To: T10 Technical Committee
From: Rob Elliott, HP (elliott@hp.com)
Date: 3 June 2002
Subject: T10/02-216r0 SAS SMP transport layer state diagrams

Figure 1. SMP transport layer state machine - application client

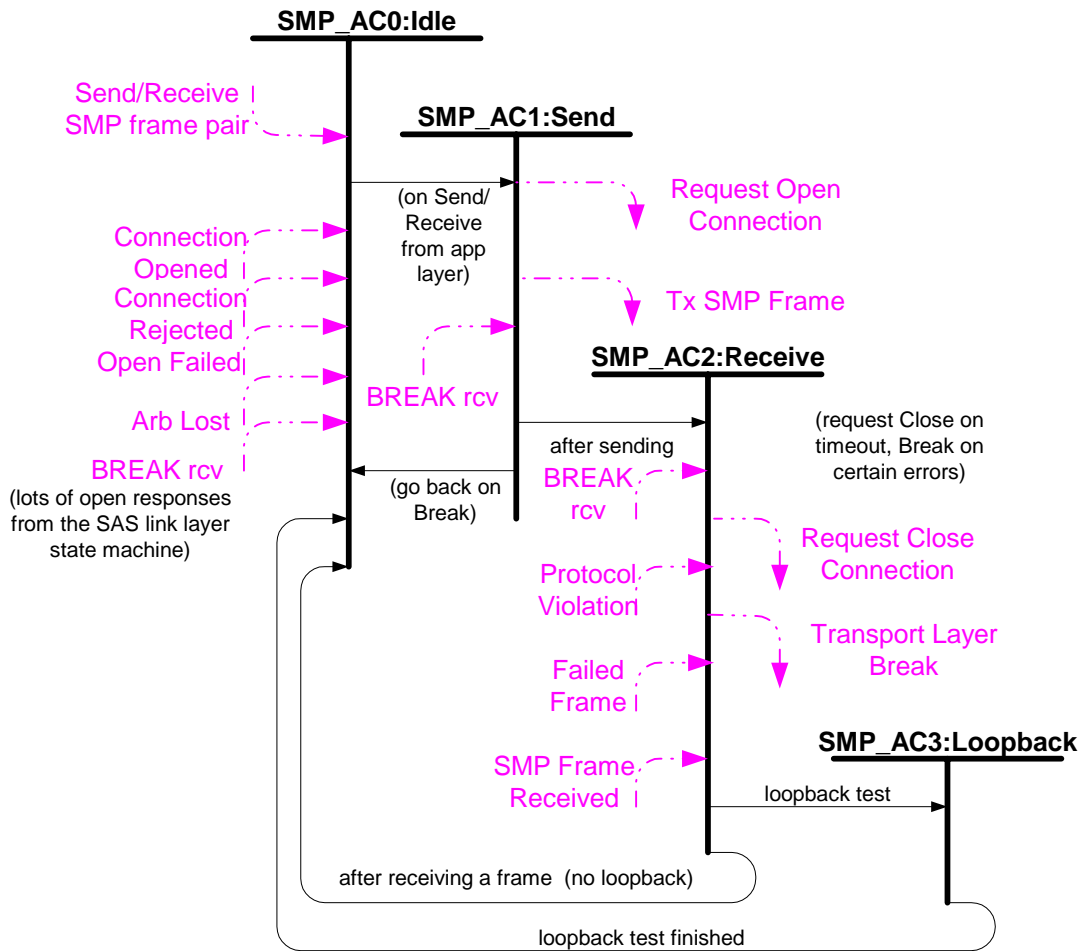
Figure xx describes the SMP transport layer state machine for an application client.

Figure 2. SMP transport layer state machine - device server

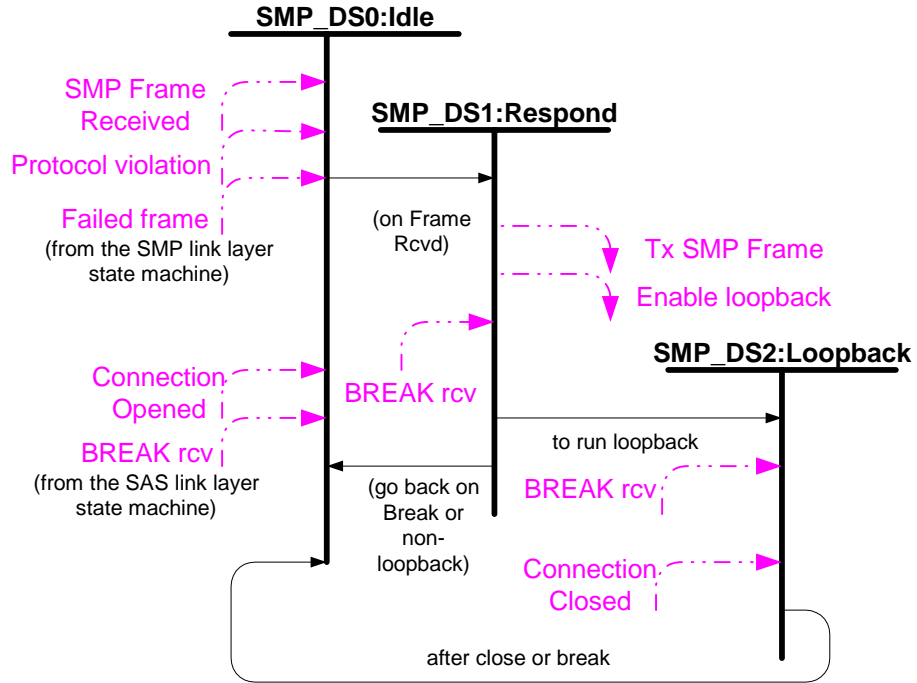
Figure yy describes the SMP transport layer state machine for a device server.
